<b>Application No.</b>	<b>Proposed Use(s) / Development(s)</b>	<b>Date of Consideration</b>	<b>Approval Conditions</b>
1.	A/NE-KTS/460	Proposed Houses	21.12.2018	(a), (b), (c), (d) and (g)
2.	A/NE-KTS/466	Proposed Residential Development and Minor Relaxation of Plot Ratio and Building Height Restrictions	13.12.2019	(a) to (f)
3.	A/NE-KTS/528	Proposed House Development	9.6.2023	(a), (b), (c), (d) and (g)
4.	A/NE-KTS/525	Proposed Residential Development and Minor Relaxation of Plot Ratio Restrictions	27.10.2023	(b) and (c)

**APPLICATION FOR PERMISSION  
UNDER SECTION 16 OF  
THE TOWN PLANNING ORDINANCE  
(CAP. 131)**

**Proposed ‘House (not elsewhere specified)’ Development and Proposed Minor Relaxation of Maximum Plot Ratio Restriction in “Residential (Group D)” Zone at Lots Nos. 407 S.A ss.2 S.A and 408 S.B ss.1 RP in D.D. 94, Hang Tau Tai Po, Kwu Tung South, New Territories (S.16 Planning Application TPB Ref: A/NE-KTS/538)**

Figure 5 - Master Layout Plan

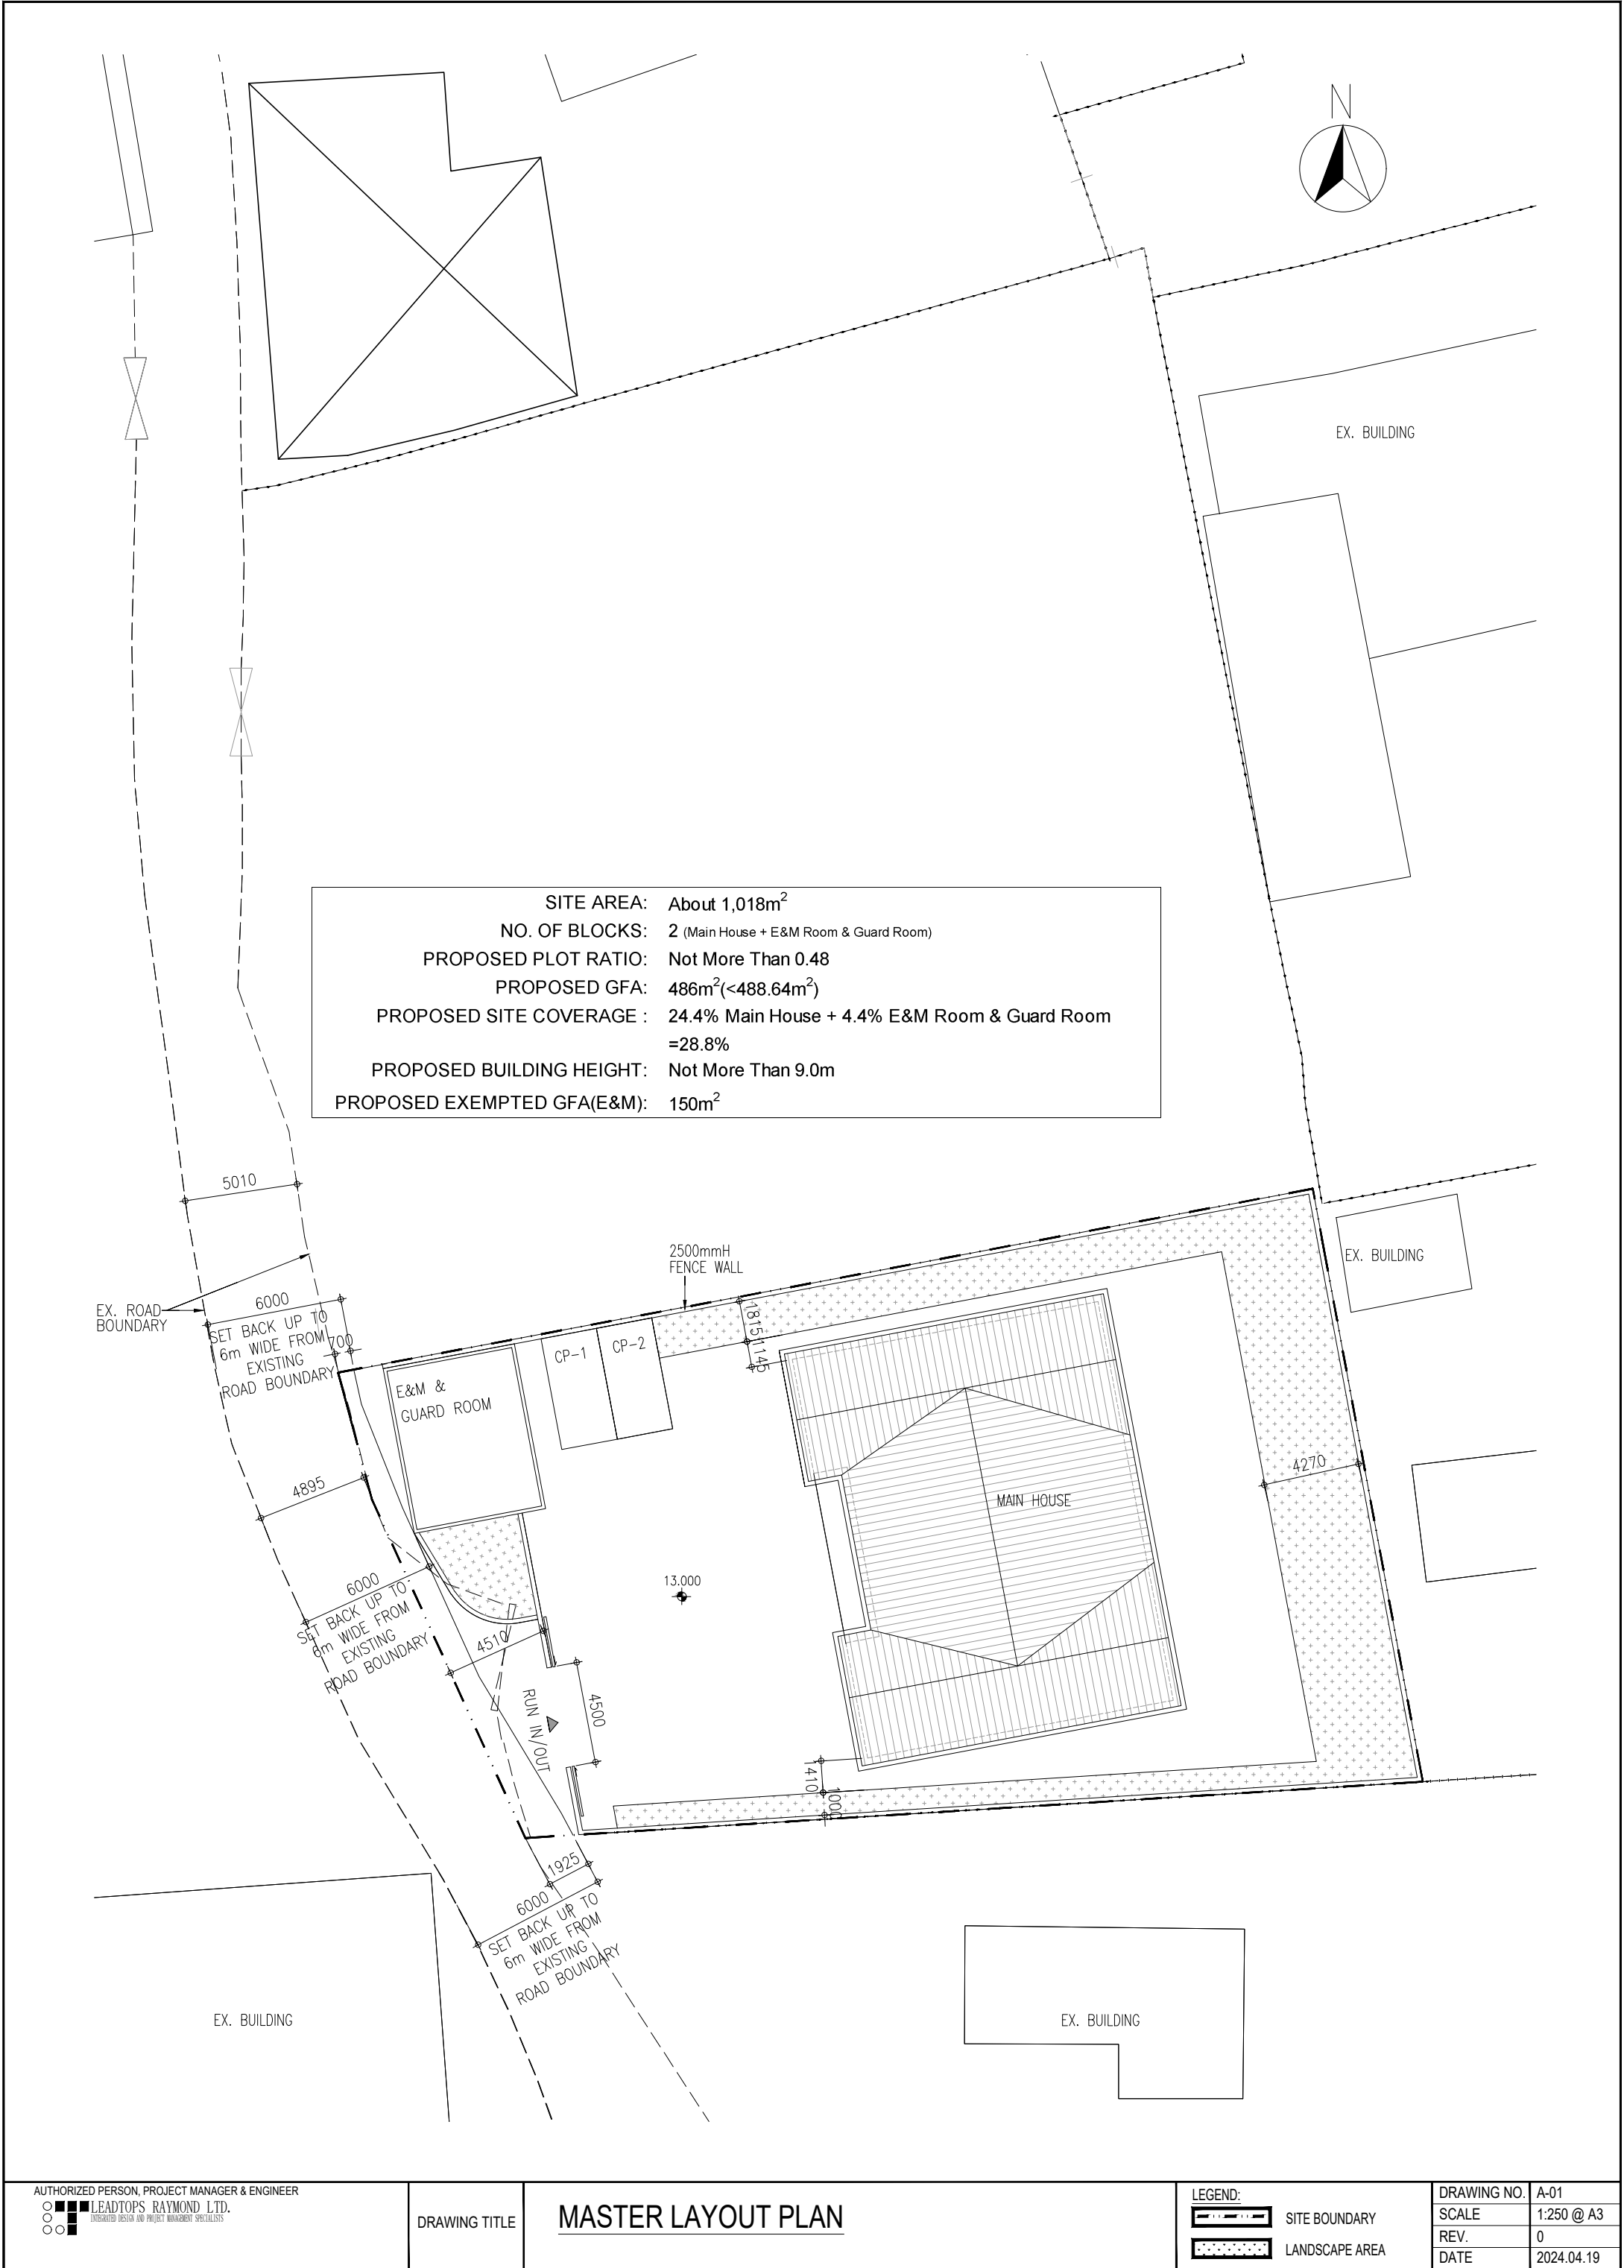
Departmental Comments		Applicant's Responses
	<p>Furthermore, by referring to Figure 5 – Master Layout Plan of the Planning Statement, the Applicant should clarify the extent of the adjoining private lots affected by the proposed road widening works. For any proposed road widening works that would affect third party private lots, the Applicant should demonstrate consent from the concerned private lot owners for the right of access, construction works, etc. have been obtained.</p>	<p>application be approved.</p> <p>No third party private lot will be affected under the current application.</p>
	<b><u>Septic Tank</u></b>

Figure 7 - Ground Floor Plan

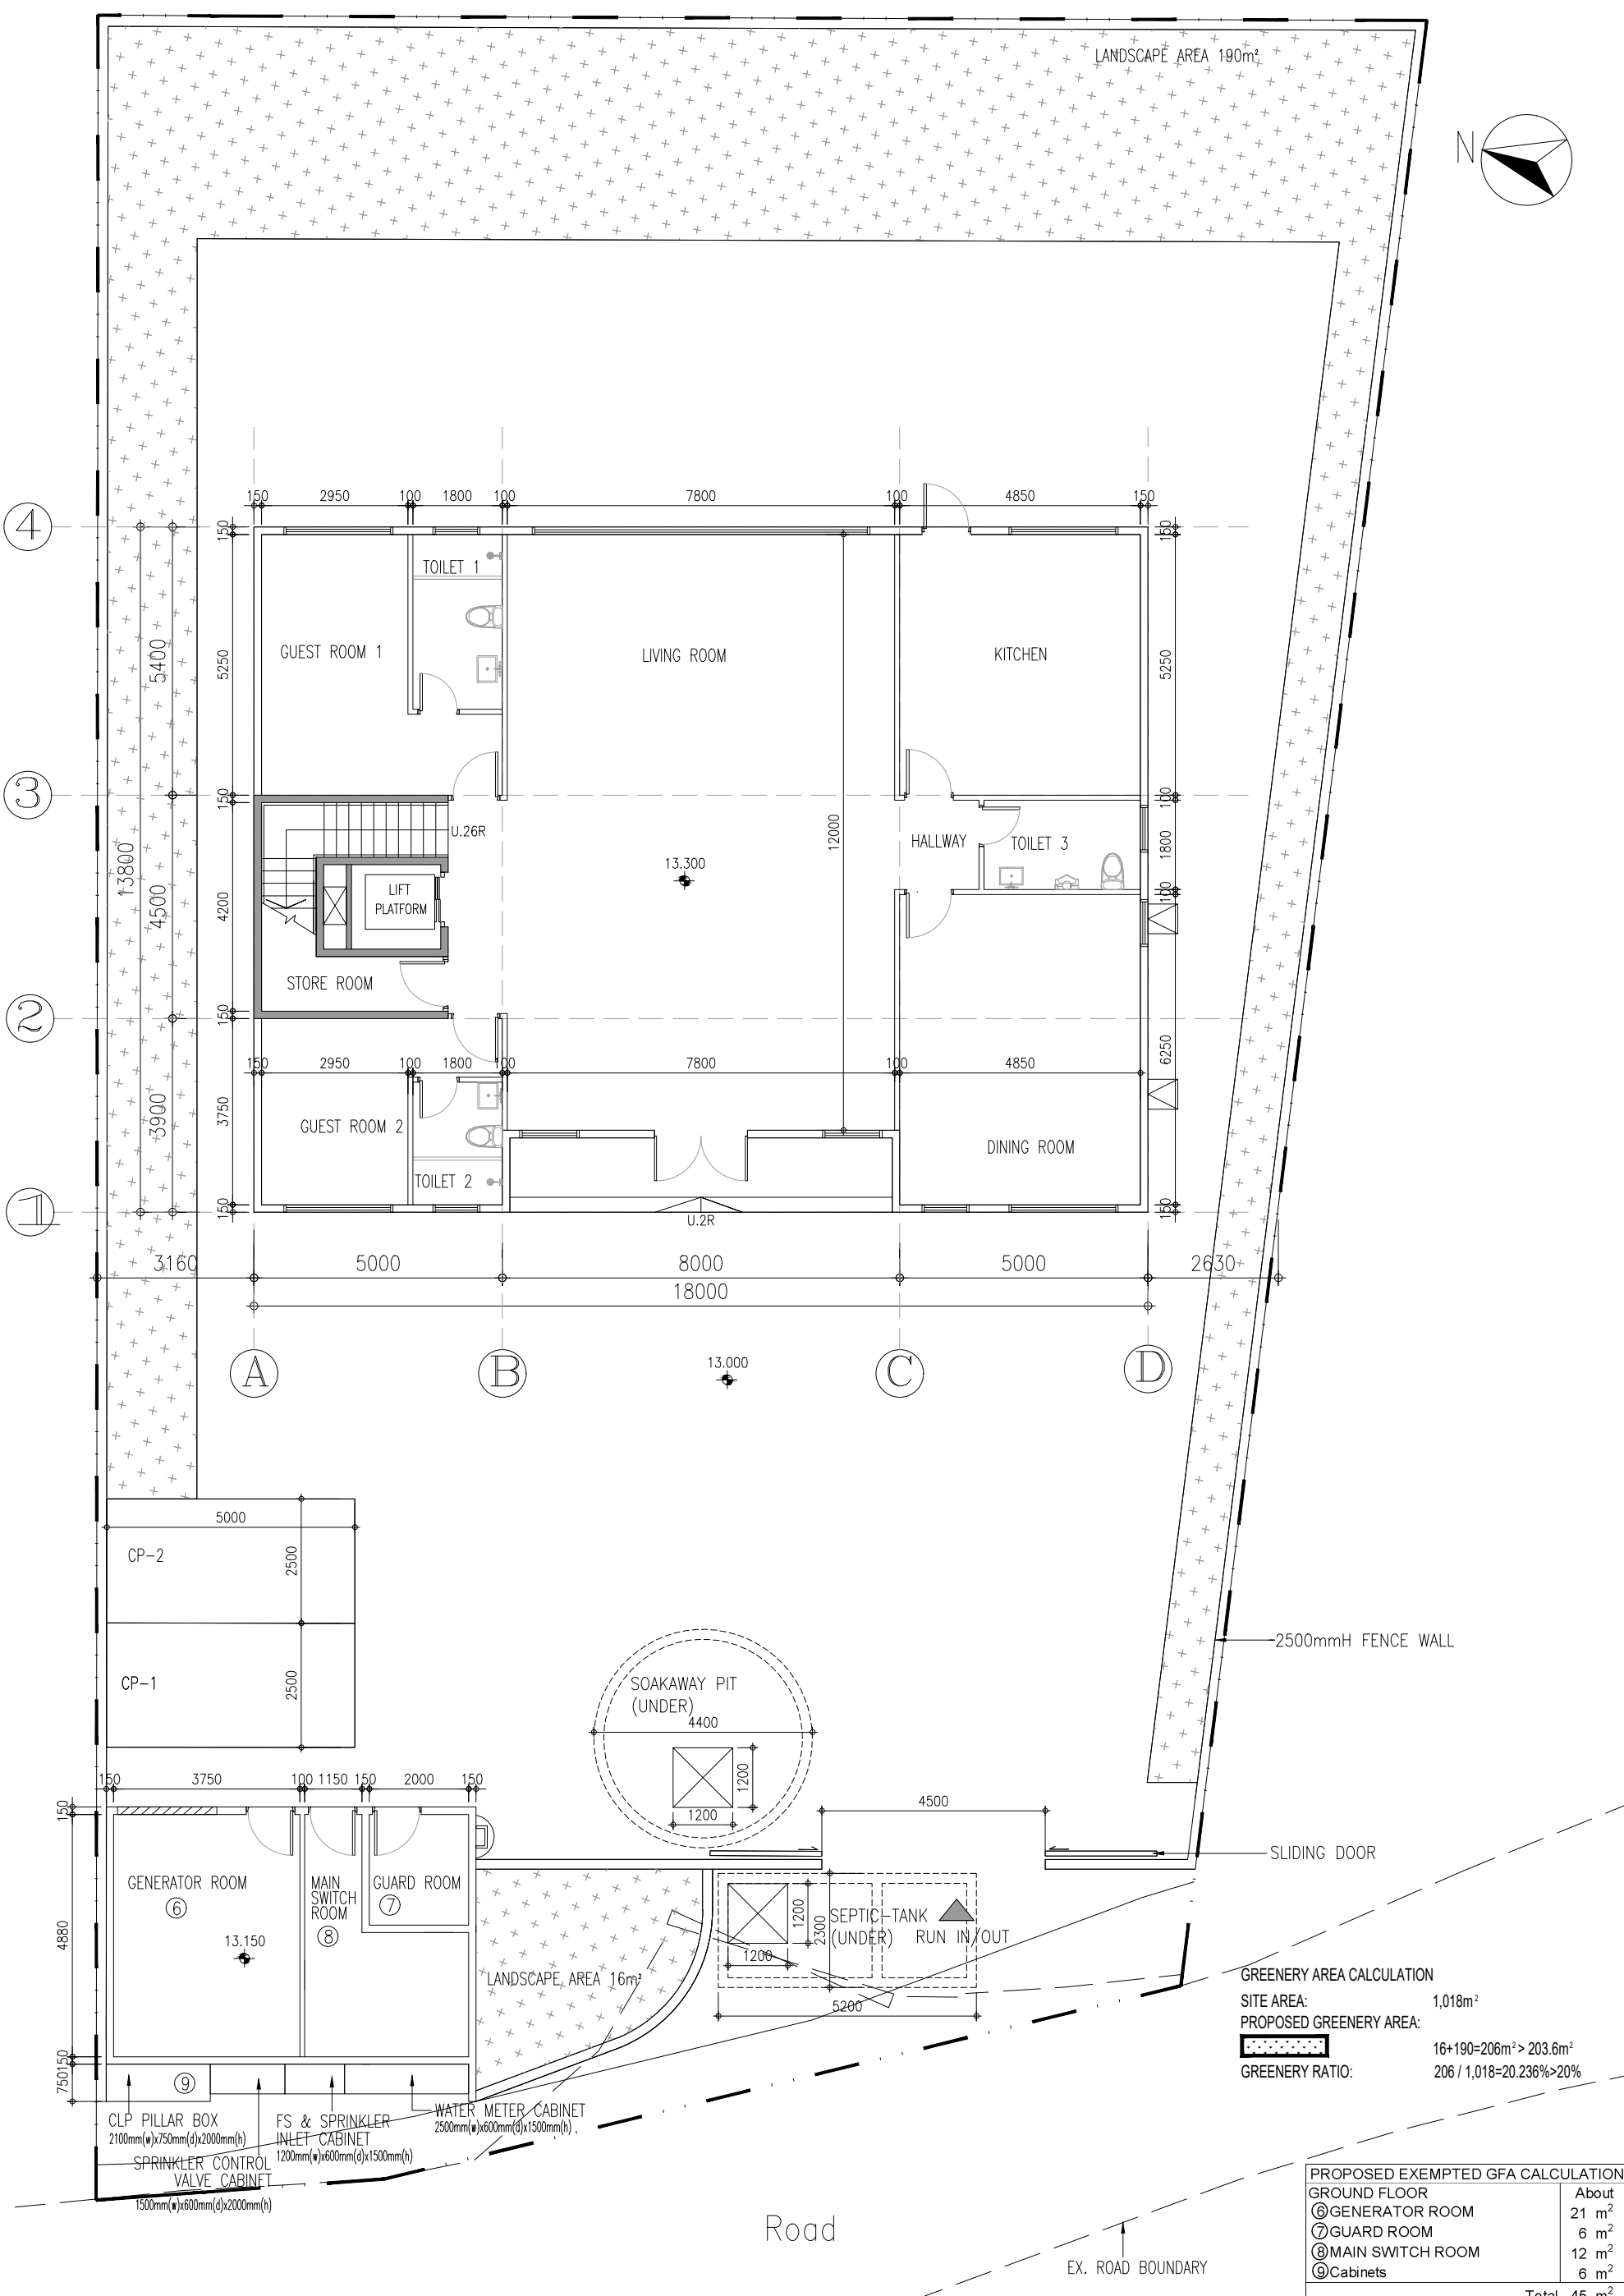
1.	<p>It is noted from the application form that the "number of units" is "1". The Applicant should note that guard room which is taken as caretakers' / watchmen's office (as shown on Figure 7 – Ground Floor Plan of the Planning Statement in this case) would in general not be exempted from gross floor area calculation in case the concerned private lot is developed as a single house development.</p> <p>Please clarify if the proposed GFA has taken into account the GFA required for the Guard Room.</p>	<p>Noted. The GFA of the Guard Room is now being included in the proposed GFA. <b>Figure 5a</b> and <b>Figure 7a</b> in <b>Annex A</b>, and para. 4.1 and <b>Table 2</b> in the Planning Statement as attached in <b>Annex B</b> have been updated accordingly.</p>
	<b><u>Widening of local access road</u></b>

Figure 5a - Master Layout Plan

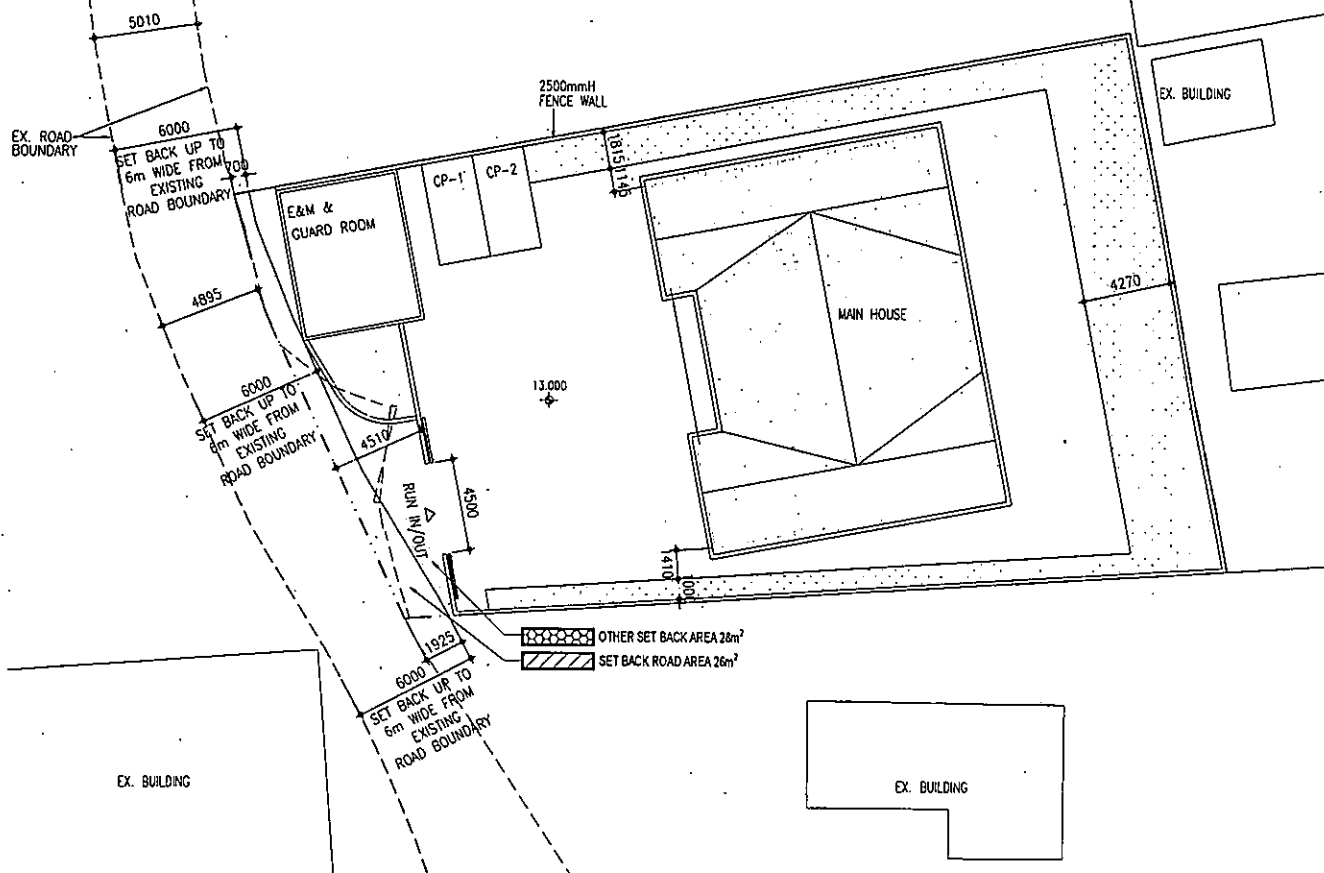
1.	The Applicant proposed in the FI a new setback area named for "self-circulation purposes" in para. 2b of its cover letter dated 11.6.2024 and marked it as "other set back area 28m <sup>2</sup> " in the revised Figure 5a – Master Layout Plan. The Applicant shall clarify the meaning of "self-circulation purposes", i.e. whether the said "other set back area 28m <sup>2</sup> " is intended to be surrendered to the Government (i.e. likewise as the "set back road area 26m <sup>2</sup> "), and its management and maintenance responsibilities.	The Applicant would like to confirm that it has no intention to surrender the "other set back area of 28m <sup>2</sup> " to the Government. This portion of the set back area will be designed, constructed, maintained and managed by the Applicant on its own expenses.
